# Access Compliance Report Public Rights-of-Way (Curb Ramps)

Main Street: N/A Cross Street: FOWLER\_AVE Location: NE

ADA ID: RPAT220301111804 Ramp Type: Type 1 - Perpendicular Initial Pass/Fail: Pass Overall Compliance: No Severity Score: 19

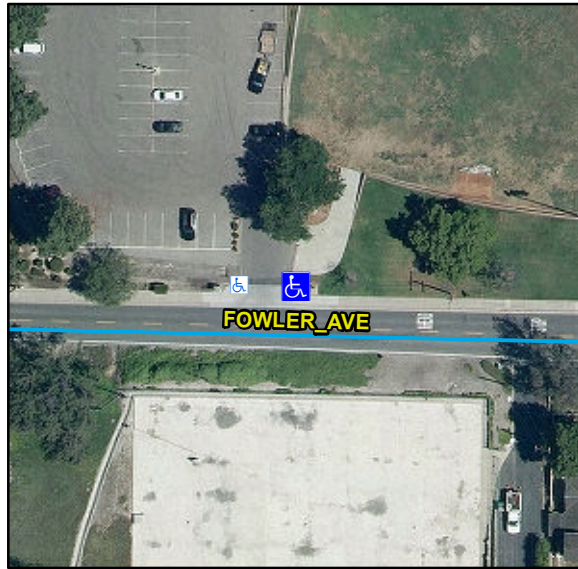
| Compliance | Description                           | Data | Compliance | Description                   | Data   |
|------------|---------------------------------------|------|------------|-------------------------------|--------|
| No         | Landing Run Slope (%)                 | 7.3  | N/A        | Flare Traversable RT          | Yes    |
| N/A        | Landing Shared                        | No   | No         | DWS Full Width                | No     |
| No         | Gutter Run Slope (%)                  | 6.6  |            | Road Cross Slope (%)          | N/A    |

Remove & Replace Entire Ramp. Remove & Replace Gutter.

R304.2.1, R304.2.2-Perp, R304.3.2-Para, R305.1.4, R304.5.4, STD 1115
